REGIONAL REVIEW NOTIFICATION

ARC REVIEW CODE: R2011191

Name of Proposal: Chosewood Development (DRI #3206)

CHOSEWOOD DEVELOPMENT DRI
City of Atlanta
Natural Resources Group Comments
November 19, 2020

DRI SITE PLAN

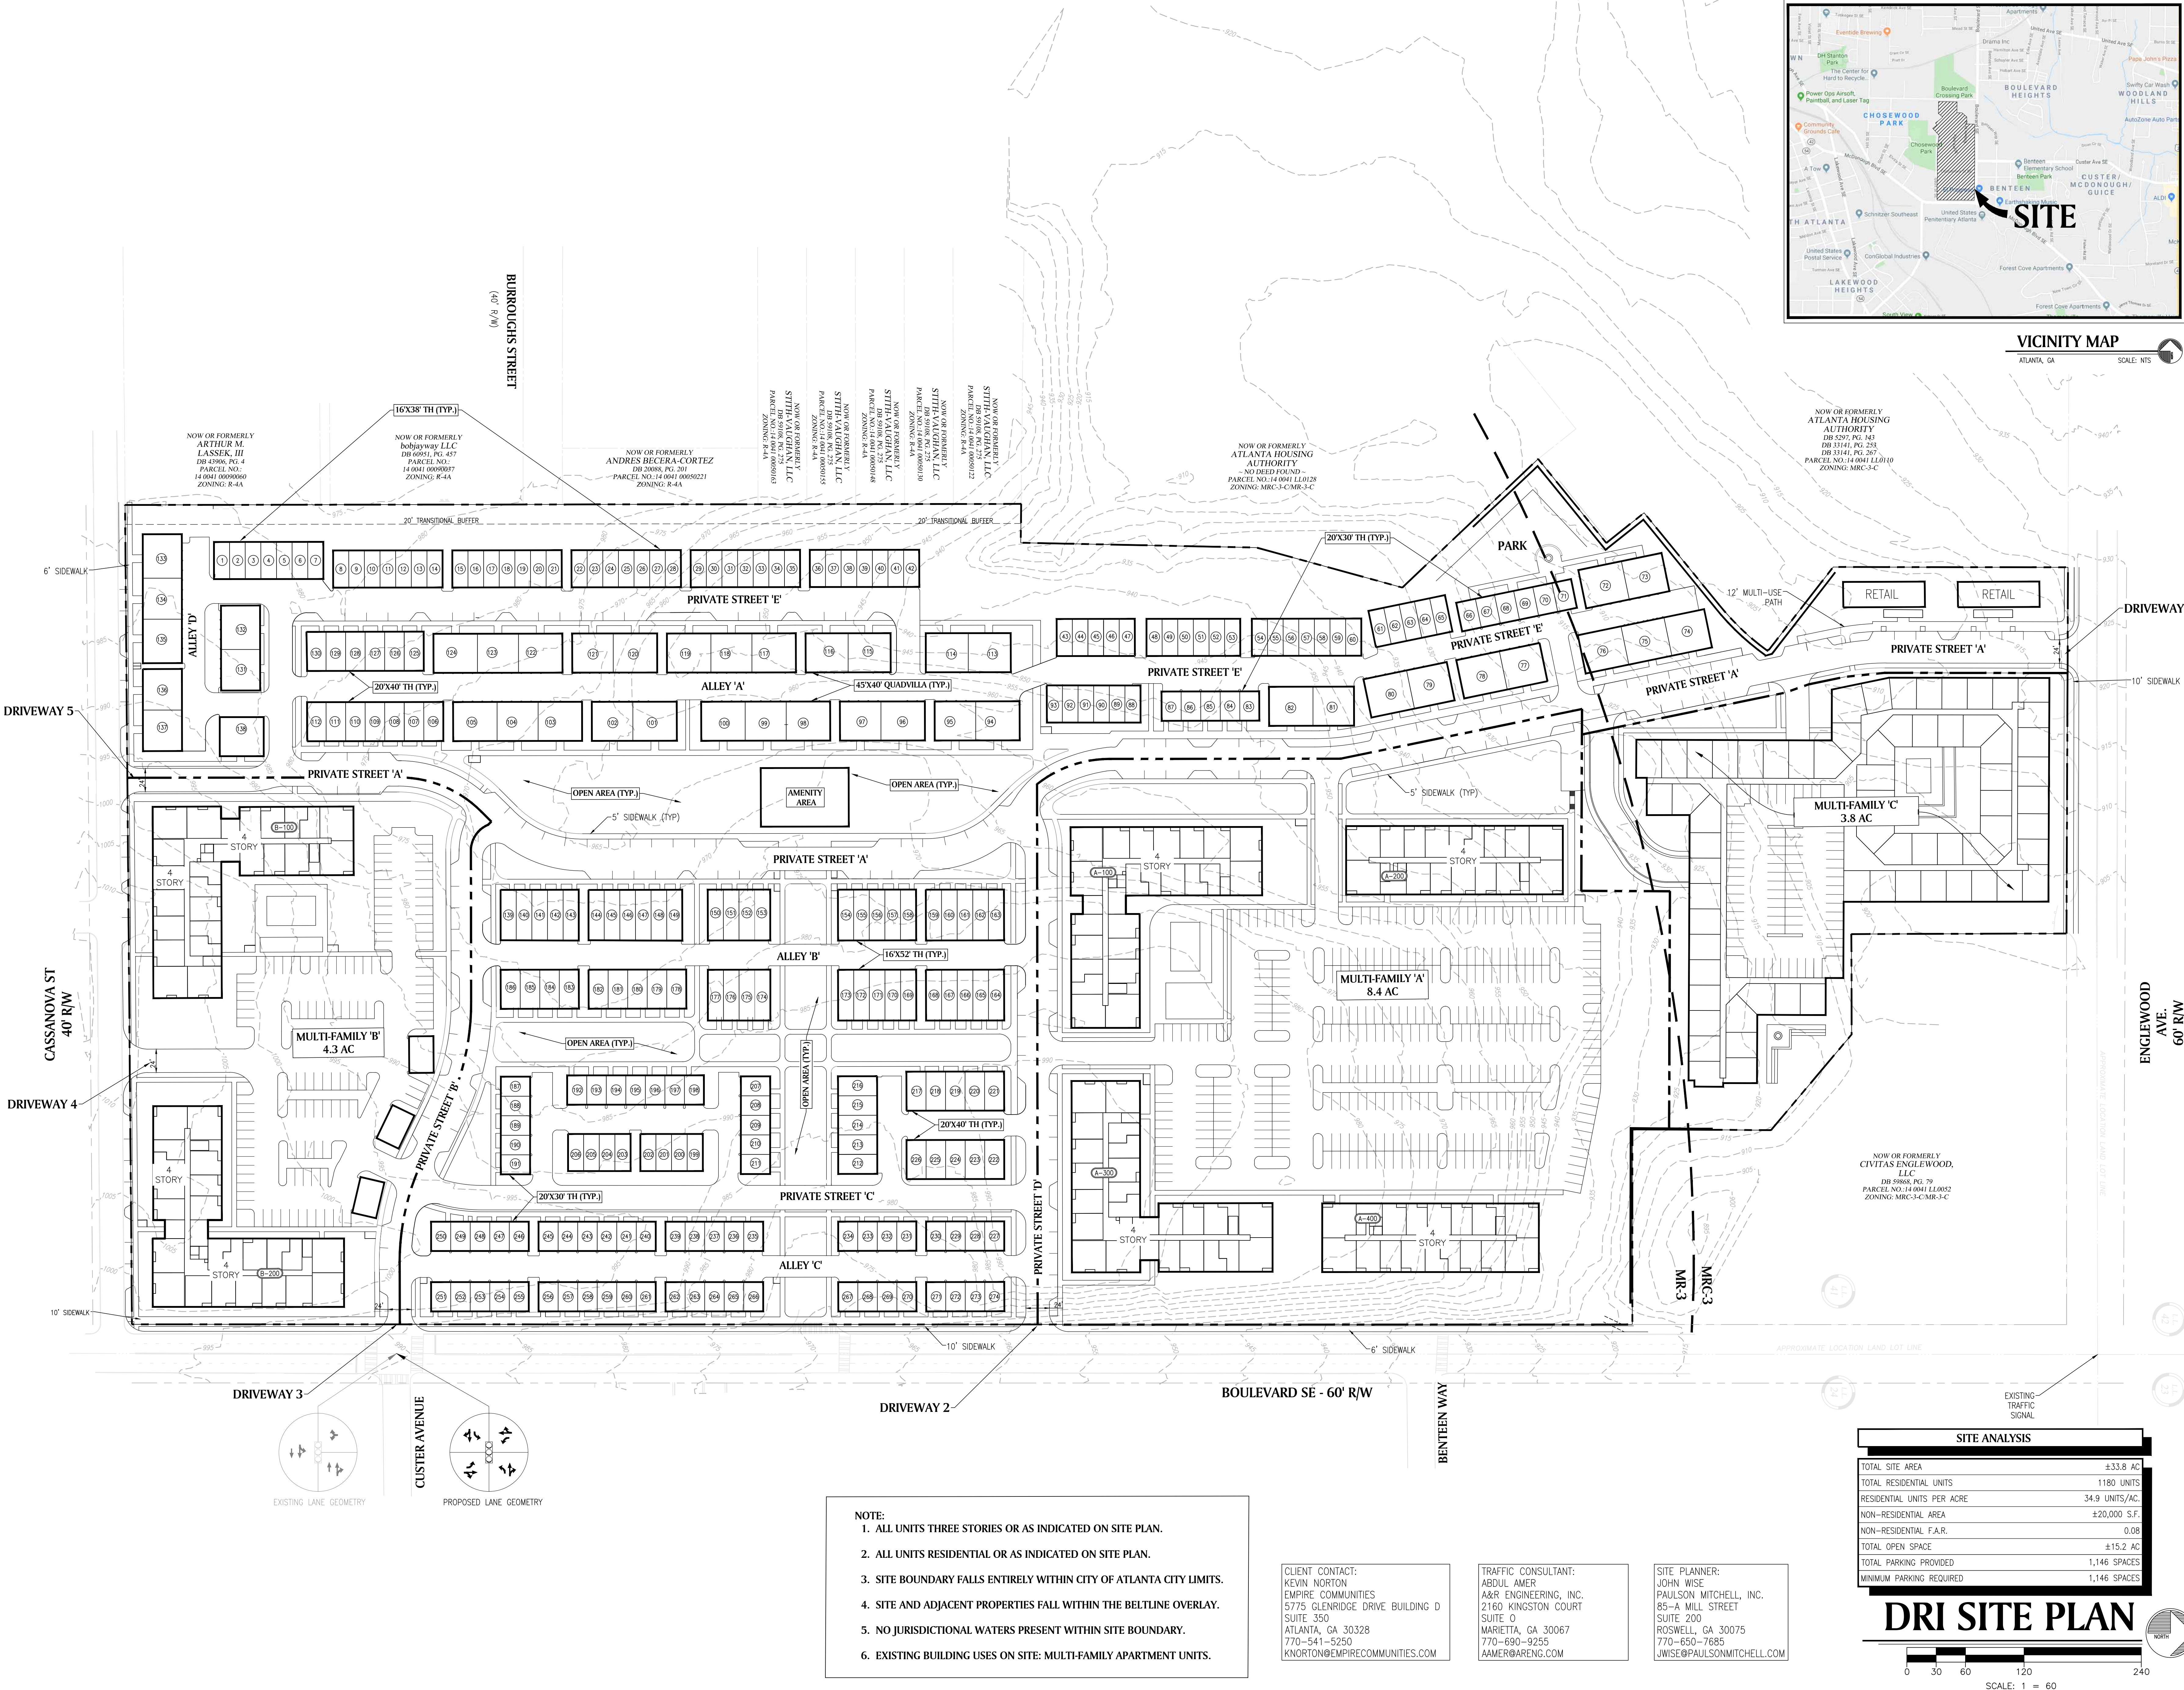
Concerns were raised during the Pre-Review Meeting for this project about the lack of a connection to the existing Burroughs Street in the southwestern corner of the DRI site. This street connection currently exists, but it was gated off to both drivers and pedestrians. The DRI as proposed would permanently preclude making this street connection in the future, which violates both the City's and the BeltLine's long-term goals of restoring and expanding the street grid. At the very least, a pedestrian connection to the existing neighborhood should be incorporated. The site plan does incorporate the potential for a future connection to the adjacent Englewood property at the northwestern corner of the site. This future street connection is also listed in the Atlanta Transportation Plan and the proposed BeltLine Subarea 3 Master Plan update. Another missed opportunity is the lack of an east-west pedestrian connection on Boulevard anywhere between Private Street D on the site plan and Englewood Avenue, along the northern edge of the Multi-Family A section. This has the effect of maintaining the existing "superblock."

Neither the submitted site plan nor the USGS coverage for the project area show any streams on the property. Any unmapped streams on the property may be subject to buffers required under the City of Atlanta Stream Buffer Ordinance. Any unmapped streams and waters of the state on the property are also subject to the State 25-foot Erosion and Sediment Control Buffer.

Develop and construction of roads/drive aisle could potentially be restricted to the west of the project site due to the Chosewood Park. The project proposes to incorporate public access to adjacent streets and internal connectivity between some of the parcels via walking and biking.
